Variant name: TE0808-05-9BI41-X

# Top View

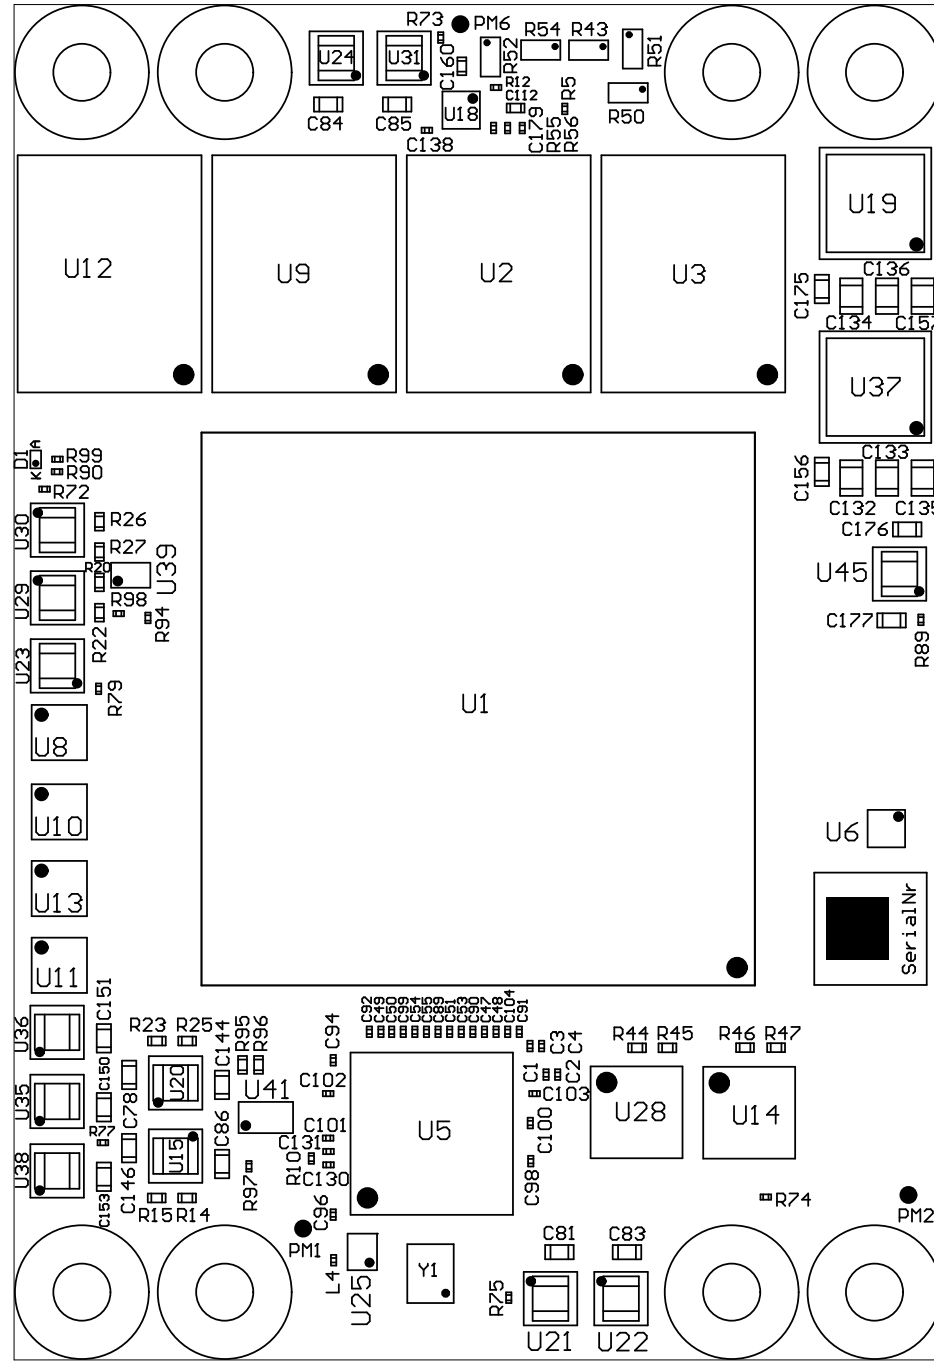
U41 Power supervisor TPS3106K33DBVR replaced by Schottky diodes SBAS70-04LT1G
